Subject: Boondocks - Parker, CO
Preliminary Site Plan Review
K/J 1446088*00 PS/PW

On behalf of the Cottonwood Water and Sanitation District (CTWD), we have reviewed the preliminary site plan submitted by MM&D Engineering Services, and we have the following comments:

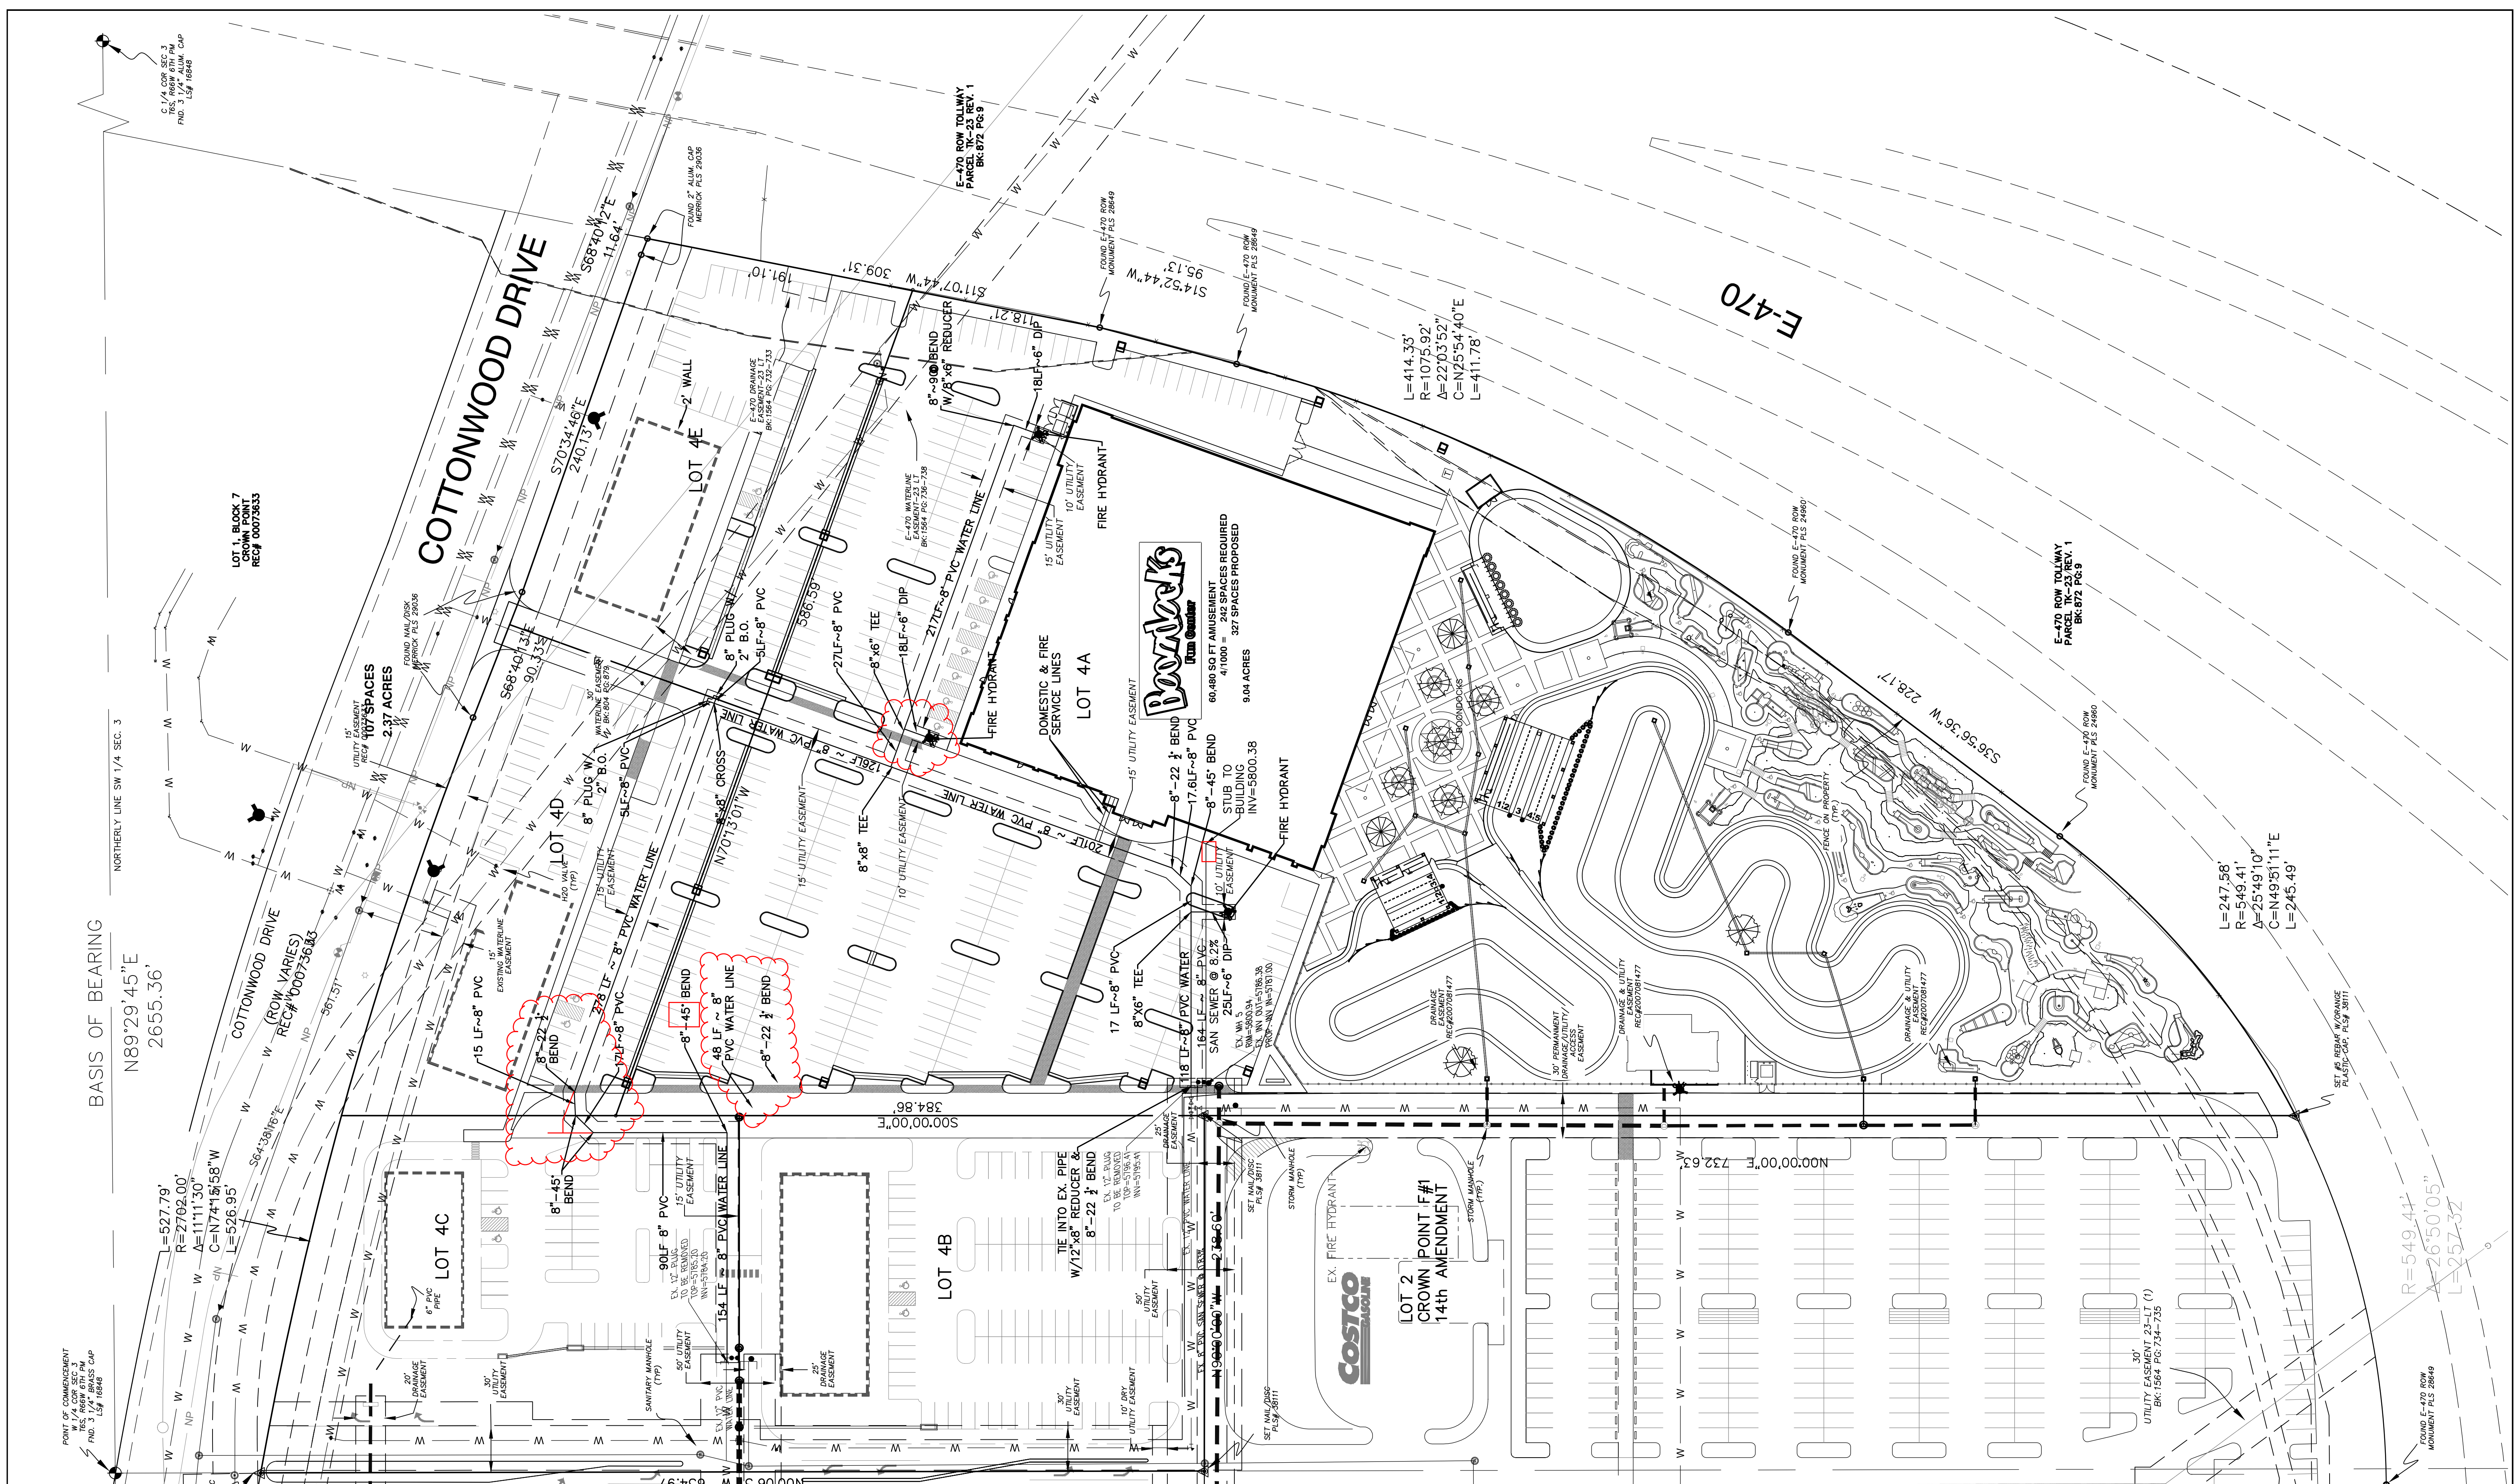
10. Only one fire hydrant is allowed on a dead end line. Please relocate the fire hydrant connection for the fire hydrant located on the northwest corner of the proposed Boondocks facility.

11. Water lines are required to have isolation valves to limit the number of fire hydrants and fire lines out of service at a time. Please revise the locations of the water valves so that only one (1) fire hydrant/fire line is out of service at any time.

12. Currently it is proposed to have two 45° bends and one 22.5° bend near Lot 4C. Please revise using a tee and the appropriate bends. Refer to the attached redlines.

13. The call out near Lot 4B is for an 8" 45° bend. We believe this should be an 8" 90° bend.
14. Show and label the existing irrigation water mains on the utility plan. Call out the size and location of the proposed irrigation tap for the Boondocks.
